Intel[®] 848P Chipset

Platform Design Guide Update

March 2004

Document Number: 254080-004

2. Replace Figure 46 “Routing Illustration for BOOTSELECT”

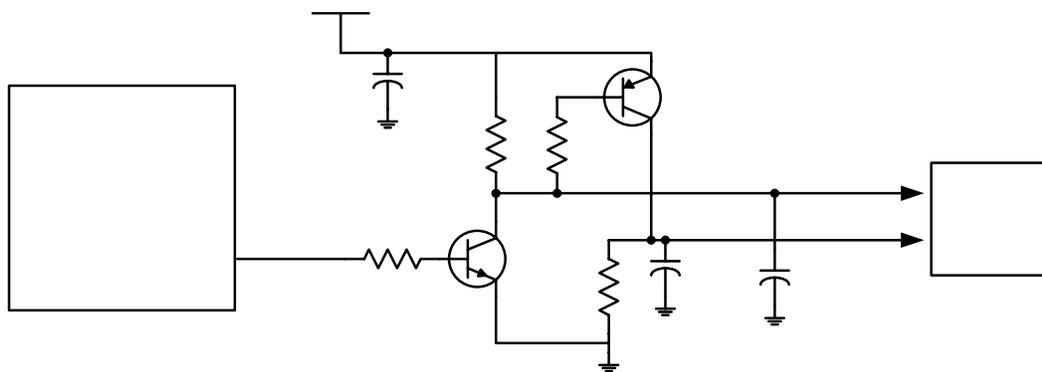
In Section 5.1.6.10 on page 80, replace Figure 46 “Routing Illustration for BOOTSELECT” with the following:
